# CITY OF GUADALUPE

PROJECT: City Hall Repair Project Design Services

**ADDENDUM NO.: 4**

**FOUNDATION & FLOOR FRAMING PLAN**

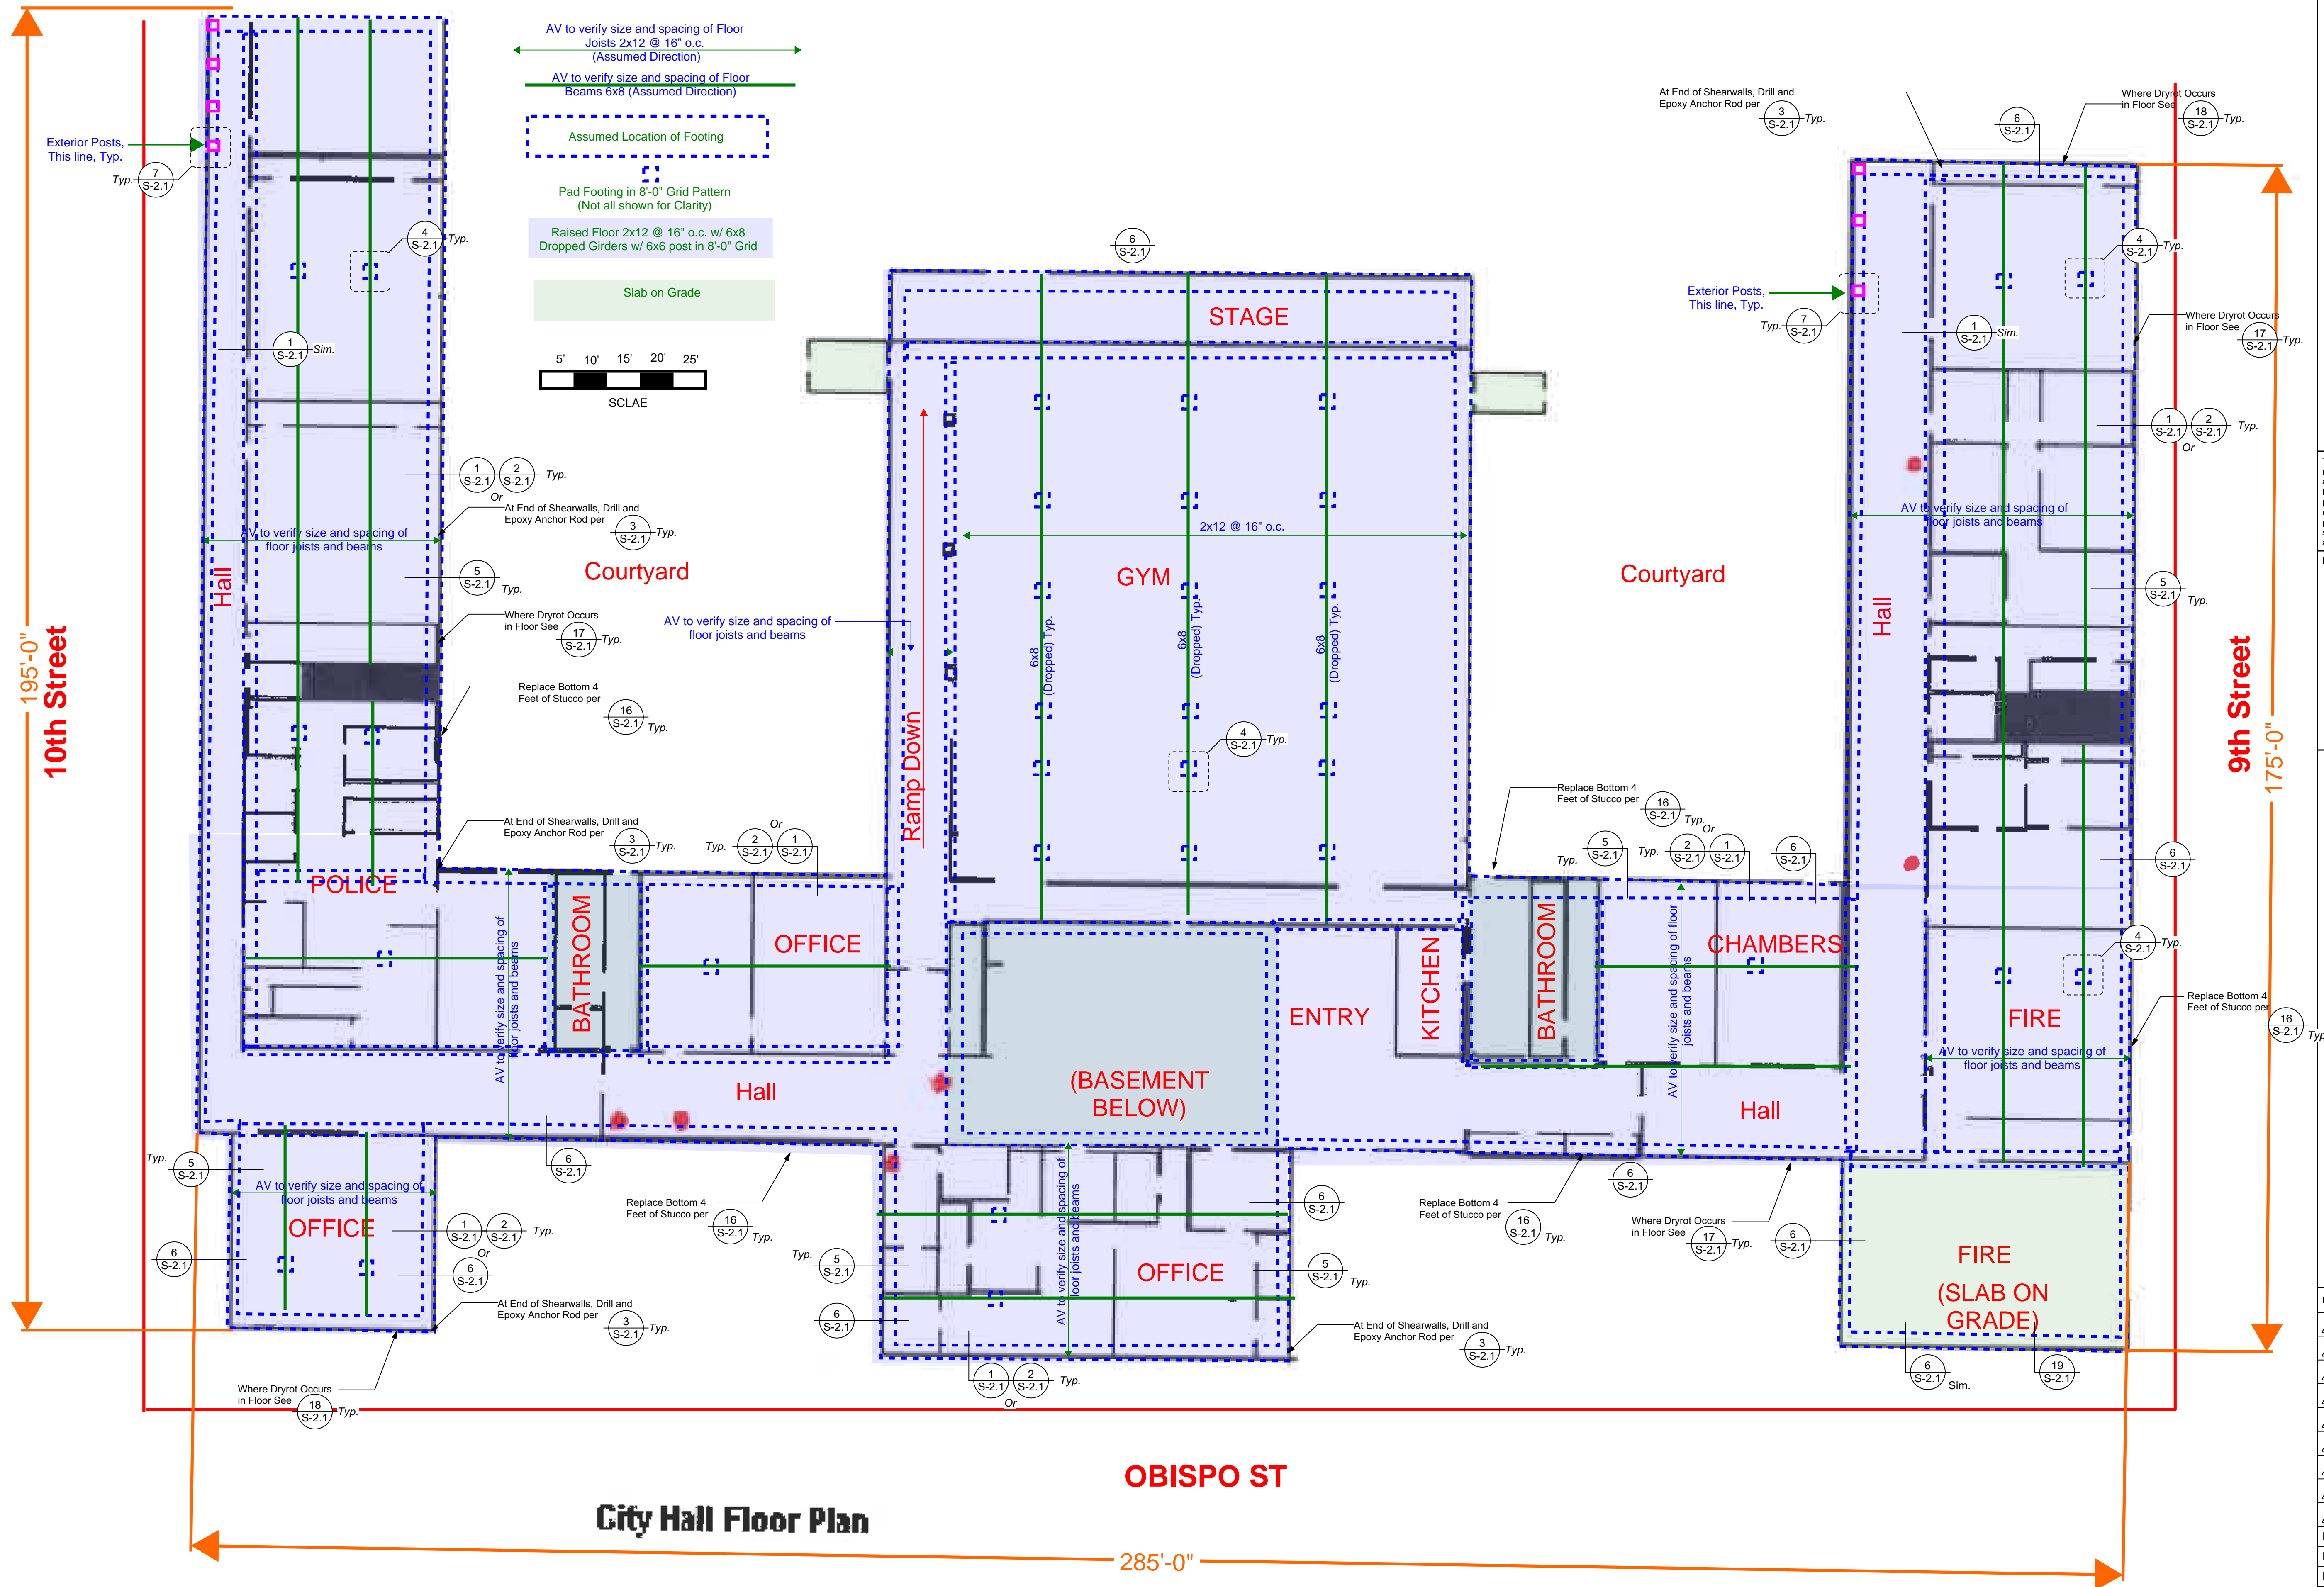
Q: The July 2022 Qualitative Structural Evaluation Report includes a Foundation & Floor Plan and a Foundation Plan (both base plans and repair plans), but they are not legible in the report. Can the original electronic PDF versions be provided during the proposal process?

A: **Yes. Provided as an attached document.**
